Product Change Notification

Date Issued :	January 30, 2023	PCN Number :	513103
Reason for Change :	Change to Product		
Description of Change :	Correction in Product drawings to match sales drawings: no red cap, label distance corrected to REF 100mm, ends of wires should be stripped REF 10mm.		
Reason for Short Notice :	Corrective Actions		
Assessment of Change :	First Article Inspection		
Planned Implementation Date :	February 28, 2023		
Sample Availability Date:	February 15, 2023		
Internal Molex Qualification Date :	February 15, 2023		
Last date to request Samples by Customer :	February 01, 2023		
Traceability Code Markings / Date :	No special marking on the product or packaging

Correction to Product drawings to match Sales drawings for standard receptacle products with engineering numbers: 1Rx000A39xxxx, 1Rx000A20xxxx and 1Rx004A20xxxx

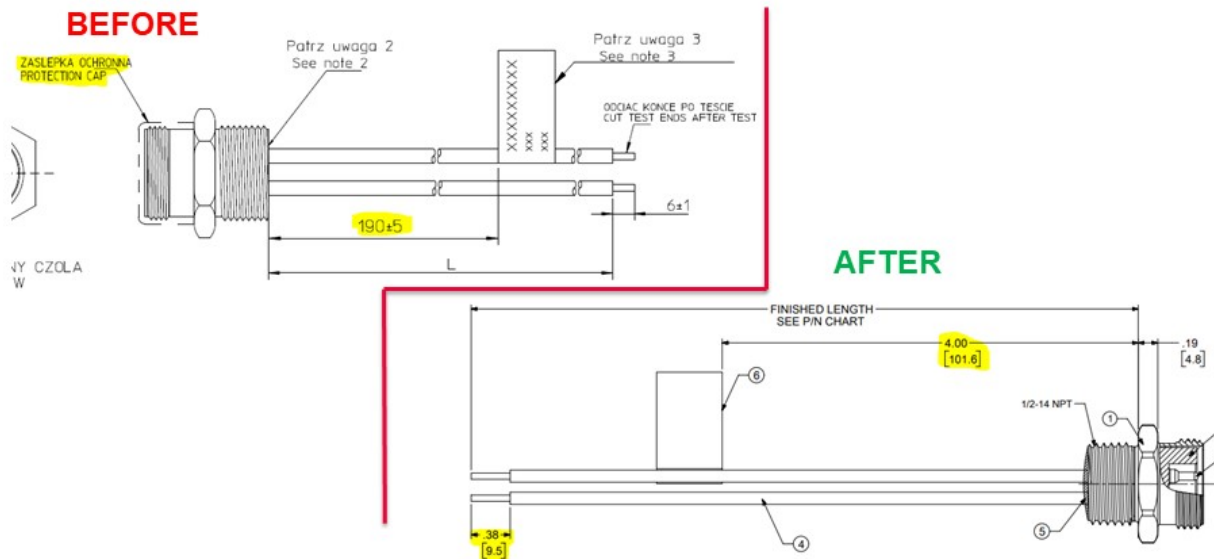
- No red cap needed for standard receptacle products. Label distance corrected to REF 100mm. Ends of wires should be stripped REF 10mm.
- Product Impact
 - impact to fit and form
- Part Number Impact
 - See attached impacted part list
